**Subject: Palo Verde Nuclear Generating Station (PVNGS)
Units 1, 2, and 3
Docket Nos. STN 50-528/529/530
Reponse to Generic Letter 95-07, Request
for Additional Information, dated June 11, 1999
(TAC NOS. M93497, M93498, M93499)**

ENCLOSURE 1 RESPONSE TO GL 95-07 PRESSURE
LOCKING AND THERMAL BINDING OF SAFETY-RELATED
POWER-OPERATED GATE VALVES RAI

**RESPONSE TO GENERIC LETTER 95-07, "PRESSURE
LOCKING AND THERMAL BINDING OF SAFETY-RELATED
POWER-OPERATED GATE VALVES," REQUEST FOR
ADDITIONAL INFORMATION**

Figure 1: Simplified Valve Gate, Bonnet, and Stem Pressure Locking Forces

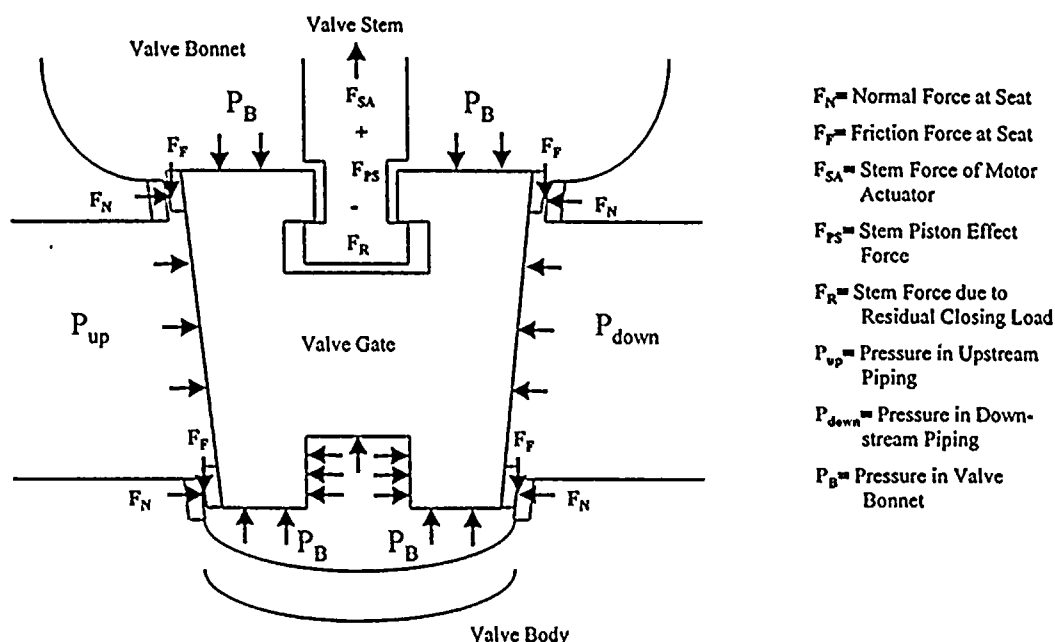
NRC QUESTION (1a):

Describe the pressure locking thrust prediction methodology and provide the test procedure/results that validate the methodology. Include any information that will help evaluate if your valves are similar to test valves as applicable.

The PVNGS pressure locking thrust prediction methodology involves the superposition of five terms to determine the postulated state of pressure locking loading. Figure 1 represents a simplified pressure locking force diagram on the valve disk and stem. The resulting equation is:

$$\text{Required Pressure Locking Stem Thrust } (F_{\text{total}}) = \text{Disk Load } (F_{\text{disk}}) + \text{Hub Load } (F_{\text{hub}}) + \text{Vertical Load } (F_{\text{vert}}) + \text{Residual Load } (F_{\text{resld}}) - \text{Stem Piston Load } (F_{\text{piston}}).$$
